BPA Ref: 3197

RE: Representation to application ref: 24/00435/FUL: Second set of revised plans for single storey rear extension, first floor side extension and associated alterations at 187 Leckhampton Road, Cheltenham, GL53 0AD

Response to findings of the Planning Officer's report – App 24/00435/FUL - 187 Leckhampton Road

Site visit 15.10.2024 – App 24/00435/FUL - 187 Leckhampton Road

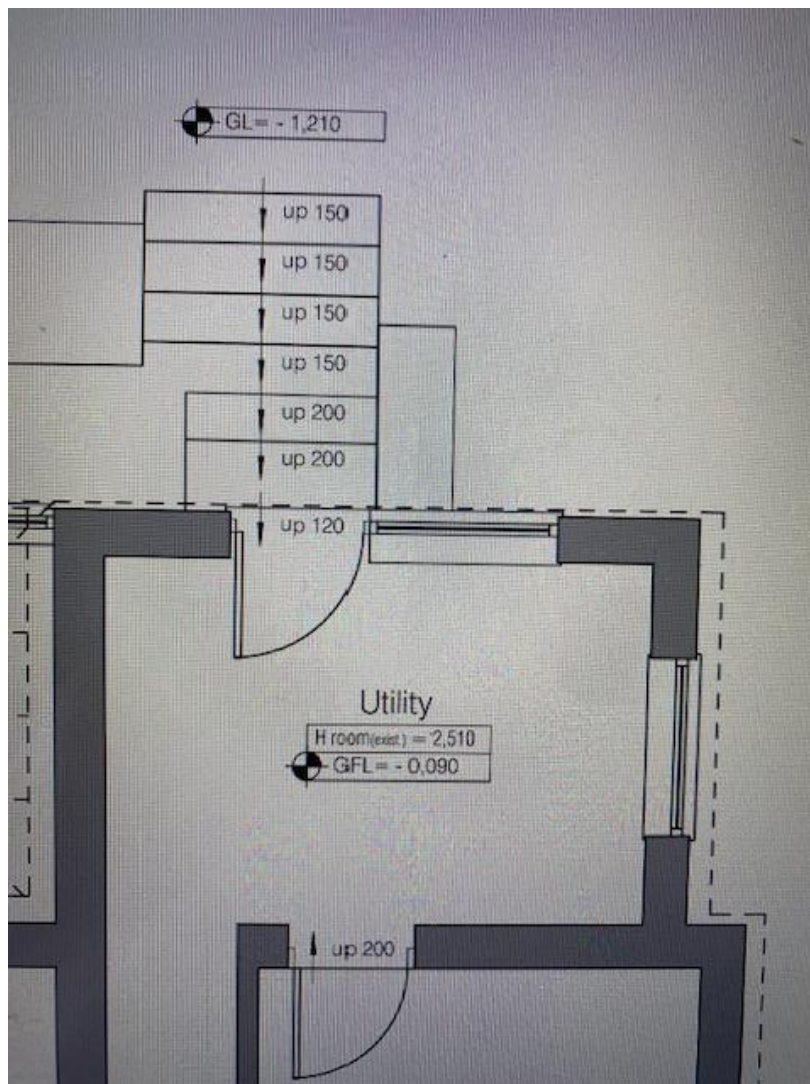
I thought I was quite conversant with the 'Existing' and 'Proposed' floor plans, however I had missed an important figure - the significant difference in floor levels between 187's current patio level and that of the proposed extension floor level. The below extract from 187's 'Existing' floor plan shows the **steps rising 520 mm from the patio level to the Utility floor**, which is the level of the proposed extension. This is only appreciated when standing in 187's current Utility room and looking down into 185's patio area.

Steps rising 520 mm = 200+200+120 mm
